Makaha Beach
Park Master Plan

Subject: Negative Declaration for Makaha Beach Park
Master Plan - Makaha, Oahu, Hawaii
Tax Map Keys 8-4-01:12 and 8-4-02: Por. 47

**MAKAHA BEACH PARK
MASTER PLAN
FINAL ENVIRONMENTAL ASSESSMENT**

FIGURE 1

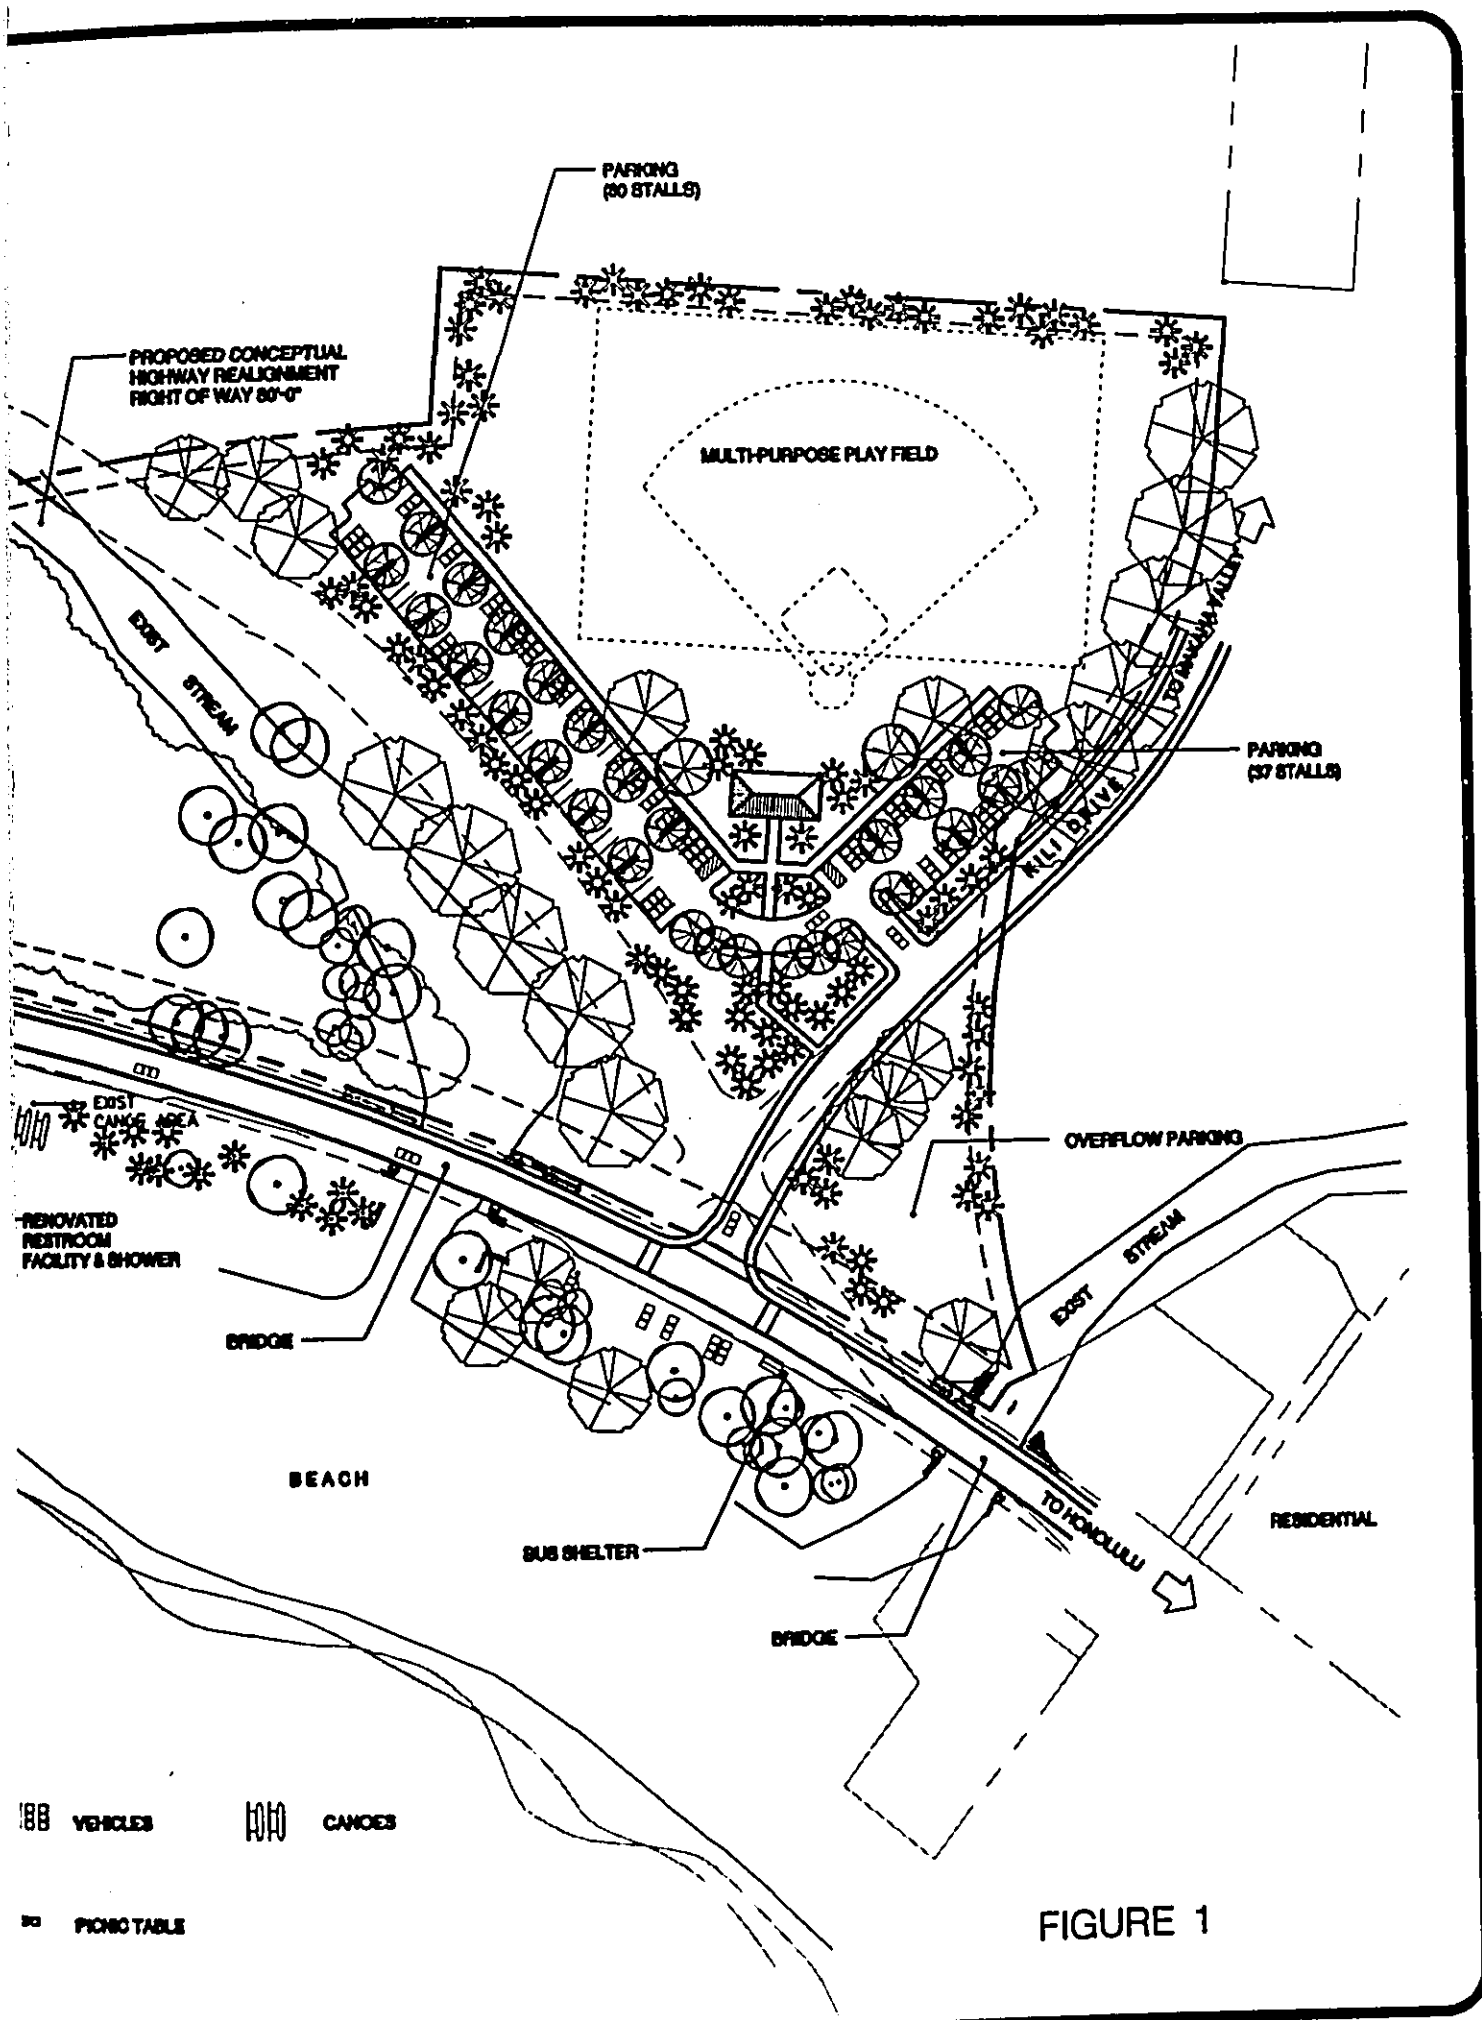
Details of the septic tank, size, capacity, plans, etc. should be included in the Final EA. The septic tank and leach field should be added to the Conceptual Master Plan (Figure 1).

If no sewer system at the time of construction, a proposal is to provide a septic tank and leaching field for liquid waste disposal. The area of the septic tank and leaching field will be approximately 75'-0" by 75'-0" (5,625 sf) and located in the parking lot adjacent to the comfort station. Normally, if there were open areas available for leaching field, that would be a preferred site. However, the picnic area may not be a desirable location as there will be inspection ports and cleanouts for the leaching field that may be punctured by tent stakes.
